NRC RAI 1-1

Indicate groove weld size that can be used interchangeably with fillet welds.

Holtec's response to RAI 1-1

Element plastic Strain in Seal Seating Region

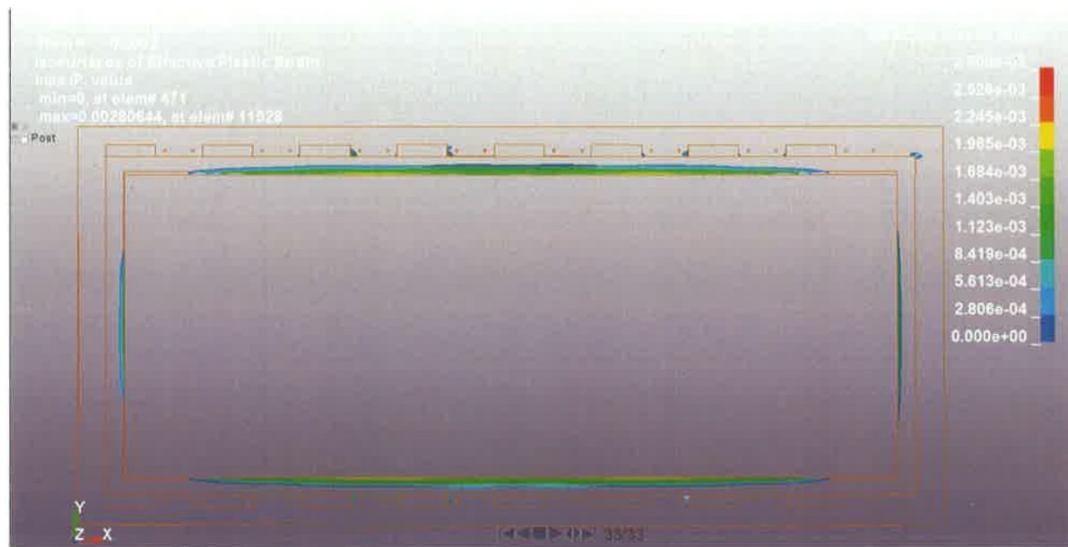
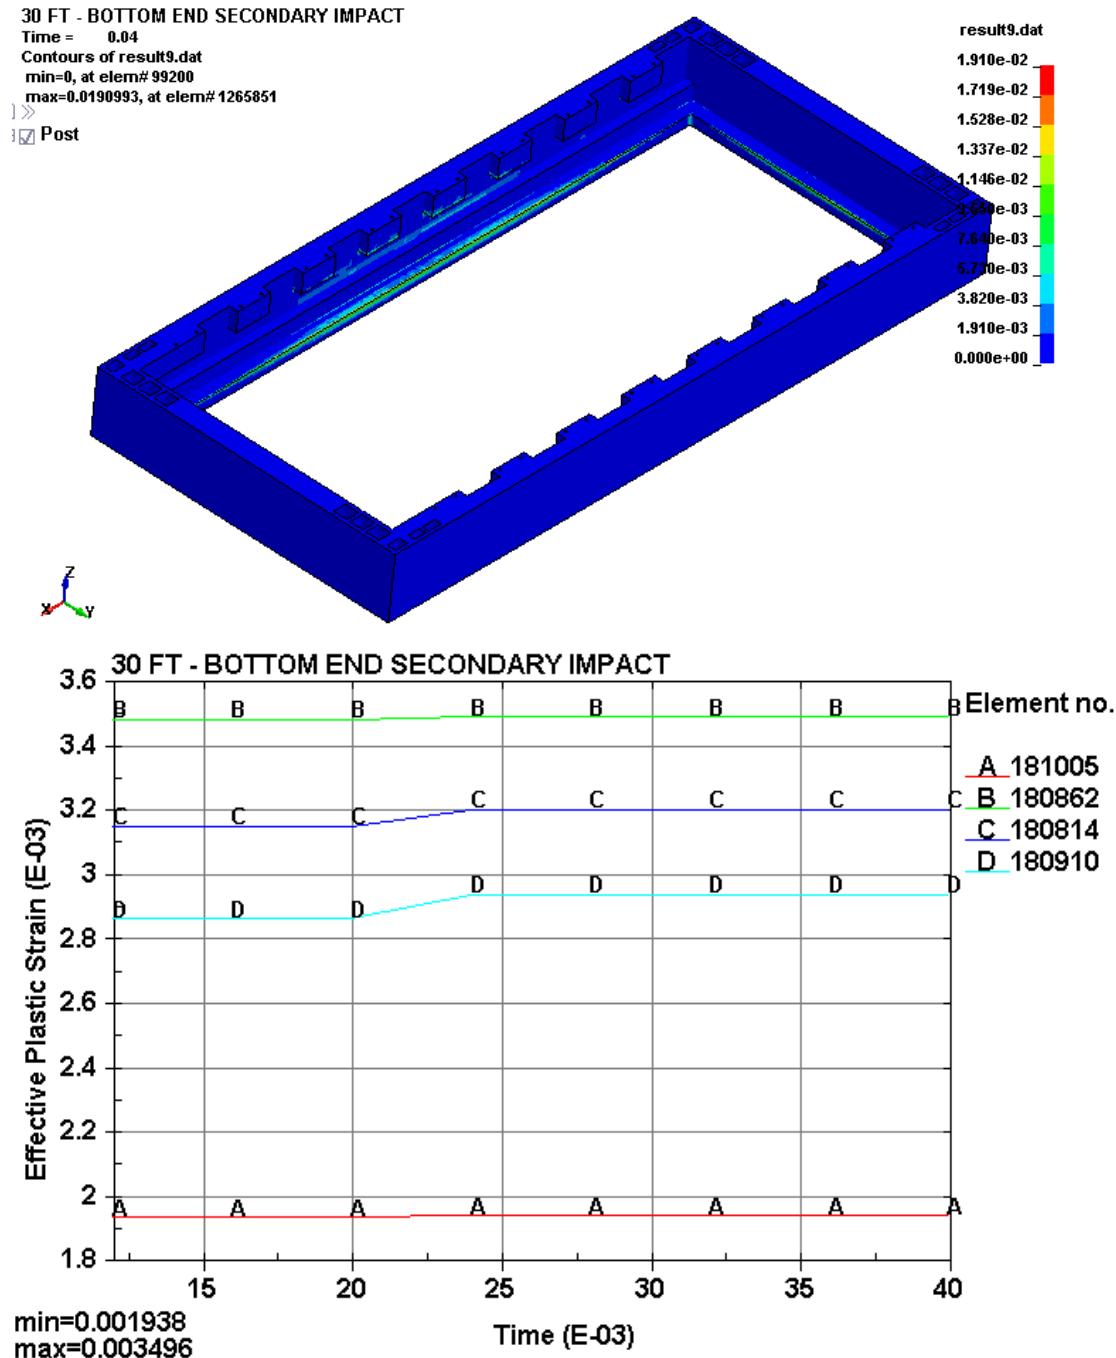
Demonstrate that the package will maintain containment under NCT and HAC tests.

An evaluation of the structural analyses shows inelastic deformation of the landing. There is no demonstration that the seal, which rests on the landing, would maintain containment after undergoing the NCT and HAC tests. The Figure below is at NCT drop; strains are greater for HAC.

With the trivial enhancements to the cask design in the flange/sealing/closure lid region, the resulting strains in the sealing region, from the updated drop simulations are noted to be insignificant (as shown in figures below). The maximum plastic strain in the sealing region are much reduced (less than 0.35%).

Figure 5-8.1

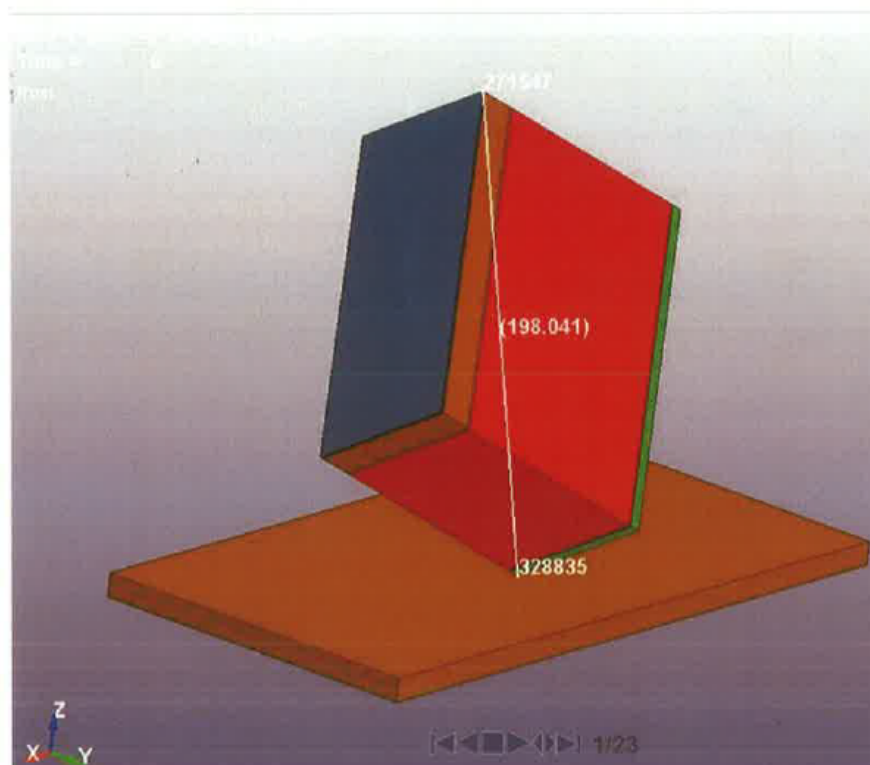
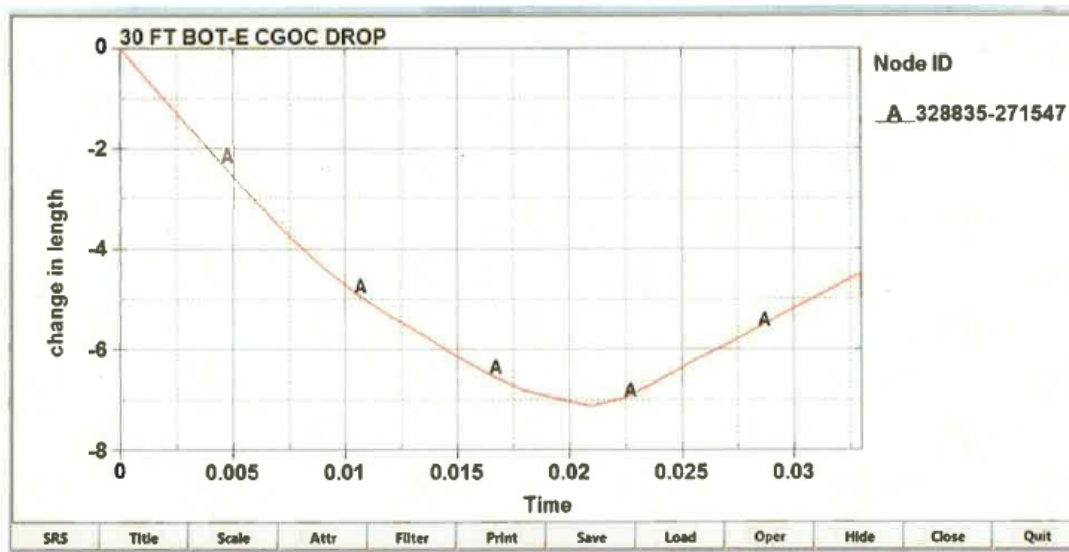
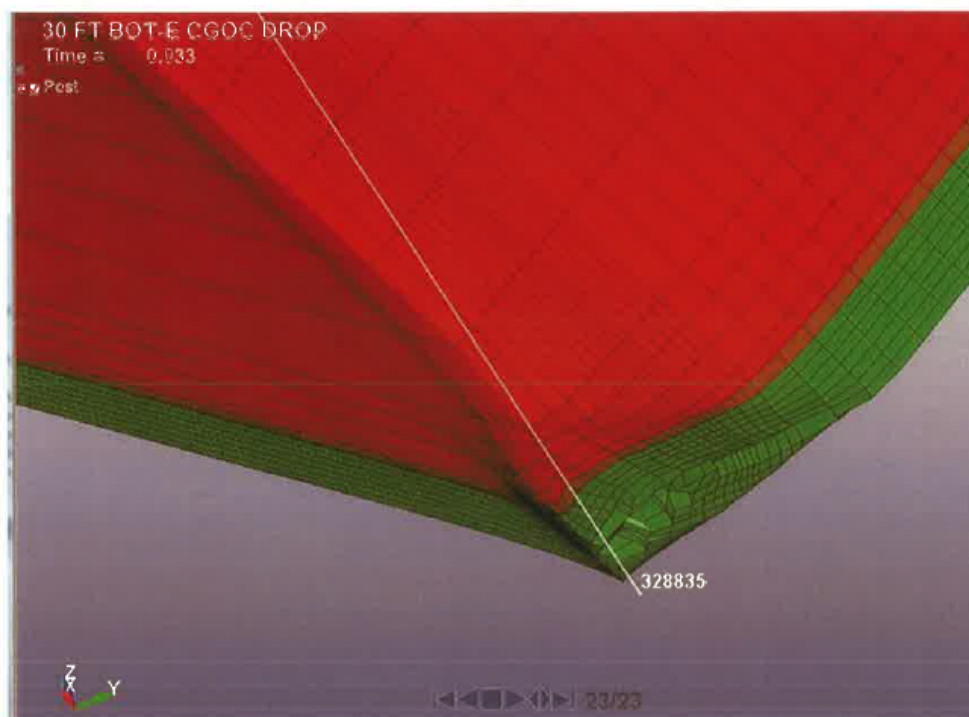
Although the staff agrees that the deformation experienced after the pin puncture would likely have a negligible impact on the dose rate at 1 meter given the margin to the limits, the staff finds that there is significant inelastic deformation, in addition to some loss of material (element erosion), that occurs at the corner directly impacted during the bottom 9m CGOC free drop simulation in LS-DYNA. Figures 5-8.1, 5-8.2 and 5-8.3 below illustrate the extent of inelastic deformation by tracking the change in length of the imaginary line between two points on the package as a function of time: the impacted corner, and the corner on the opposing corner of the package. The graph implies that the struck corner deforms as much as 7 inches during the simulation relative to its pre-impact location terminating, with more than 4 inches of permanent deformation (note element erosion at the impact site around node 328835). Note that other measures could also indicate additional information.

The applicant needs to provide a dose rate analysis demonstrating that the simulated deformation and material loss would not cause an increase in external dose rates beyond regulatory limits, while concurrently considering the streaming from conditions of the BFA-tanks and BTC (see RAI 5-5).

As a defense in depth, slightly more than 4 inches of material erosion along a bottom long edge of the HI-STAR ATB 1T is considered (See Figure 5.3.9). This is a very conservative model since material erosion is assumed to occur along the entire bottom long edge and not just a single cask corner. In the updated bounding accident case, tallies are placed 1 meter from external surfaces of the cask with the least through thickness between the source region(s) and the outside of the HI-STAR ATB 1T cask including from the surface created by the damaged long bottom corner edge. Updated design basis accident conditions dose rate results are presented for this configuration in Table 5.1.3.

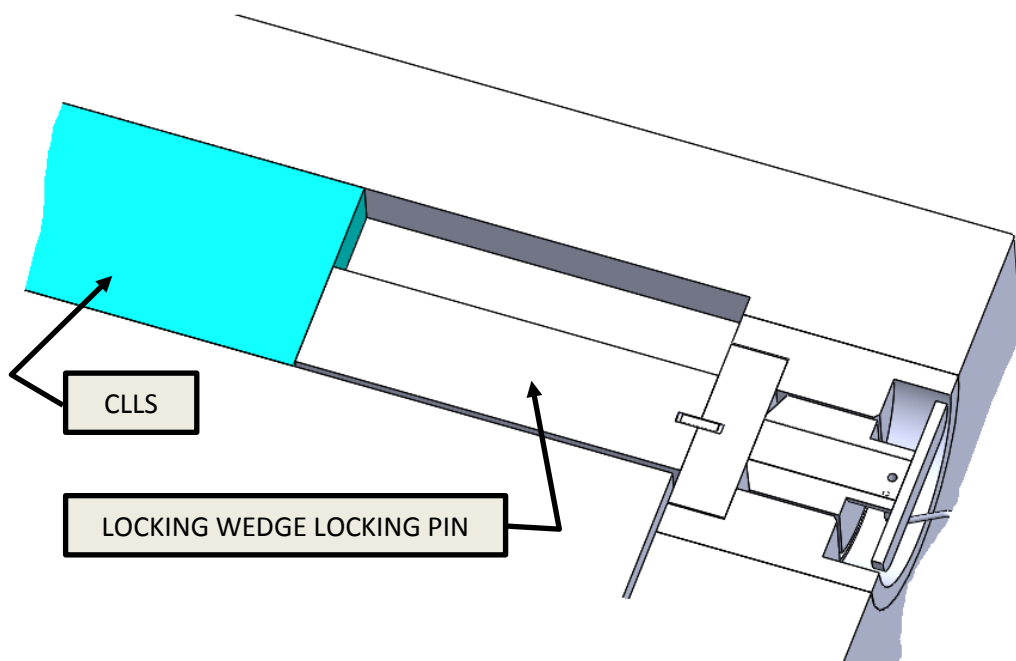
Provide the acceptance criteria that ensures the CLLS system has been fully engaged/locked and will provide containment for internal and external pressures.

Section 7.1.3 indicate that Locking Wedge Locking Pins are inserted to ensure the CLLS remains engaged during shipment. However, an acceptance criteria, such as locking pin insertion length or hydraulic pressure for locking, was not provided. The acceptance criteria would be the equivalent of a bolt torque for a typical lid closure.

It should be noted that the closure lid Shear Bars also engage with the closure lid, as shown in licensing drawing 9786. The function of the Shear Bars is to provide additional safety assurance by improving the margin of safety against seal leakage (containment breach), as discussed in Section 2.7 of the SAR. The Shear Bars are not relied upon to ensure the CLLS remains fully engaged. However, in addition to adding actions to cover the operational step of inserting the Shear Bars in Step 3 of 7.1.3 (as shown above), similar edits have been made in Step 5 of Section 7.1.1.1, Step 4 of Section 7.2.2 and Step 3 of Section 7.3.1 to include Shear Bar insertion/removal as part of the operations.
